## ADDENDUM No. 2

### RFP No. 18-31

#### Progressive Design-Build for WTP SCADA Modernization

# Existing Floor Diagram

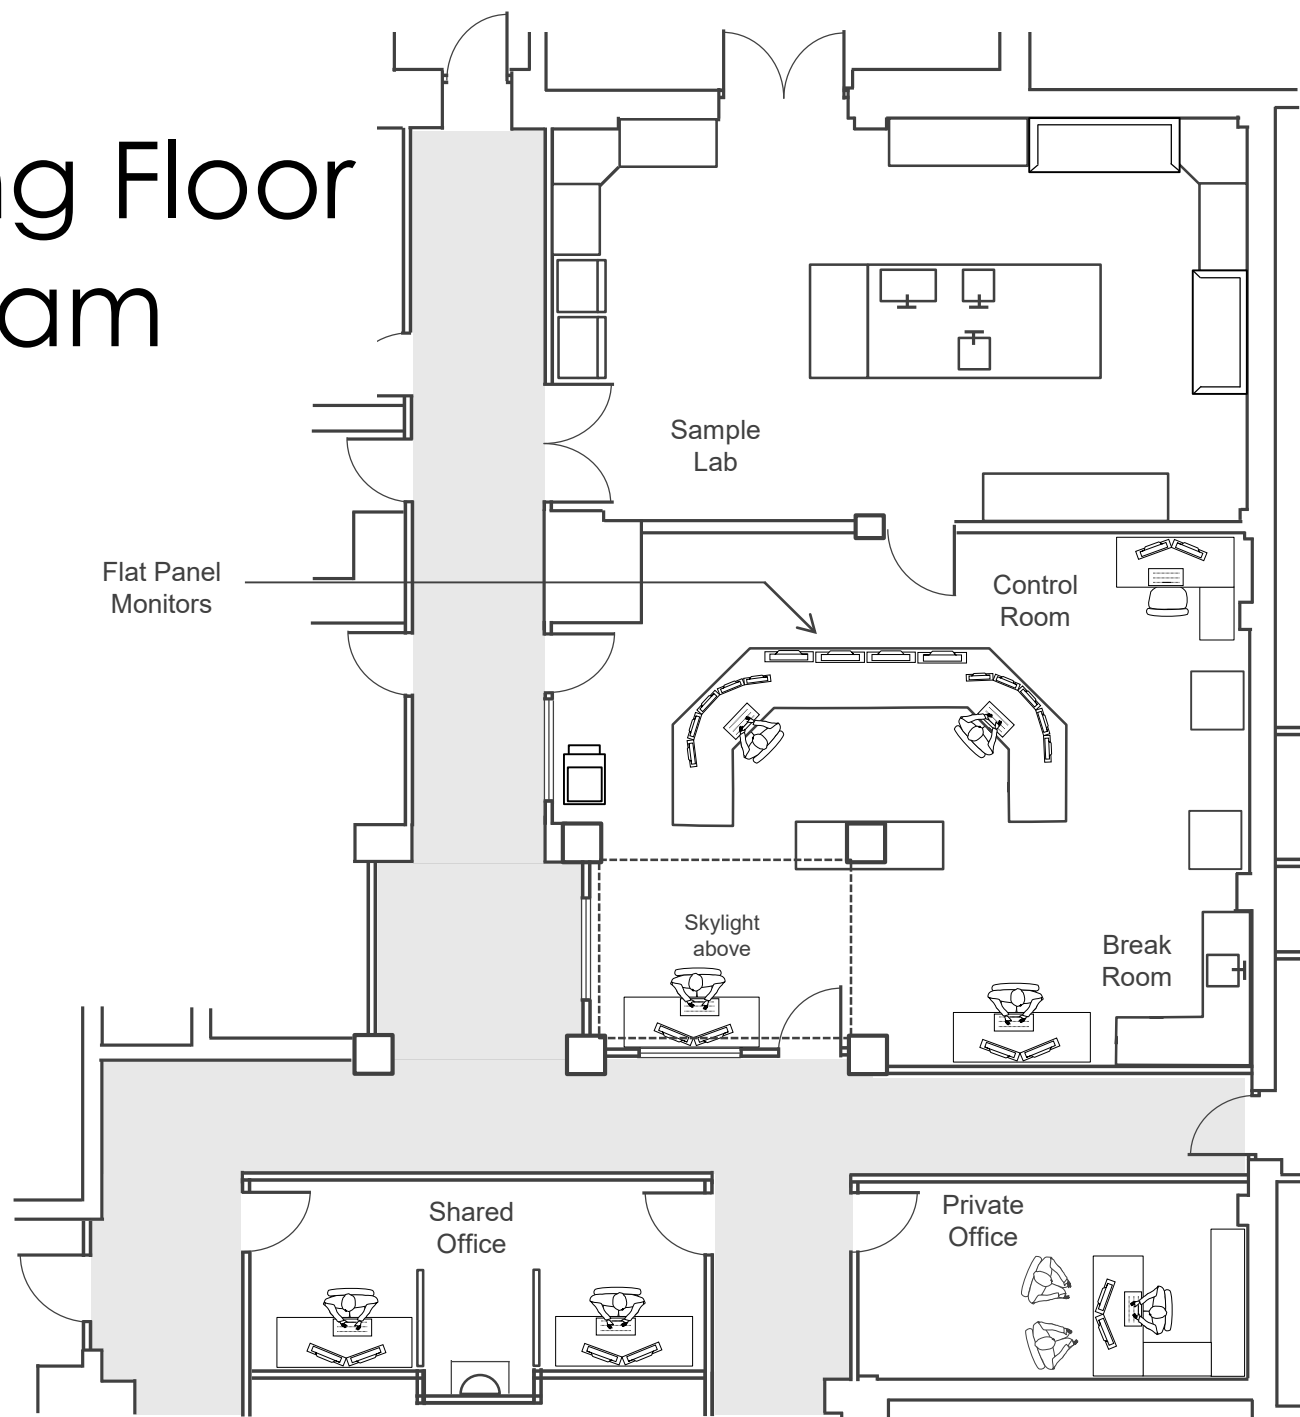
Q5: Can a floor plan of the existing control room be provided?  
 A5: Yes. Please see Attachment A at the end of this addendum.
